# Access Compliance Report

## Public Rights-of-Way

Intersection ID: 43535	Main Street: AMBROSIA_ST	Cross Street: PLANTERS_WATCH_DR	Location: SW
ADA ID: A71164E6AC62	Ramp Type: PerpDiag	Initial Pass/Fail: Fail	Overall Compliance: No
		Severity Score: 30

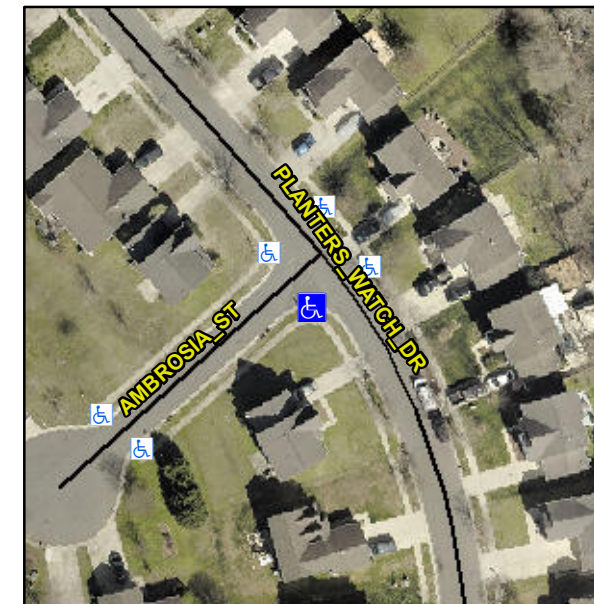
**R304.5.1, R304.5.3**

Compliance	Description	Data	Compliance	Description	Data
N/A	Ramp Length (in)	47.0	Yes	Ramp Slope (%)	5.6
No	Ramp Width (in)	35.0	No	Ramp XSlope (%)	5.1
N/A	Flare Type LT	N/A	N/A	Flare Type RT	N/A
N/A	Flare Slope LT (%)	N/A	N/A	Flare Slope RT (%)	N/A
N/A	Flare Traversable LT?	N/A	N/A	Flare Traversable RT?	N/A
N/A	Landing Length (in)	N/A	N/A	DWS Provided?	N/A
N/A	Landing Width (in)	N/A	N/A	DWS Contrast?	N/A
N/A	Landing Slope (%)	N/A	N/A	DWS Length (in)	N/A
N/A	Landing X Slope (%)	N/A	N/A	DWS Full Width?	N/A
N/A	Landing Curb? (Y/N)	N/A	N/A	DWS Offset (in)	N/A
N/A	Shared Landing?	N/A			
N/A	Gutter Ponding?	N/A	N/A	Gutter Slope (%)	N/A
N/A	Gutter Lip Ht (in)	N/A	N/A	Gutter X Slope (%)	N/A
N/A	Painted X Walk1?	No	N/A	Painted X Walk2?	No
	X Walk 1 Direction	To NE		X Walk 2 Direction	To NW
N/A	X Walk 1 Width (in)	N/A	N/A	X Walk 2 Width (in)	N/A
	X Walk 1 Slope (%)	3.0		X Walk 2 Slope (%)	1.3
	X Walk 1 X Slope (%)	0.5		X Walk 2 X Slope (%)	1.4

**Remove & Replace Curb Ramp With Two New Directional Ramps or Equivalent.**
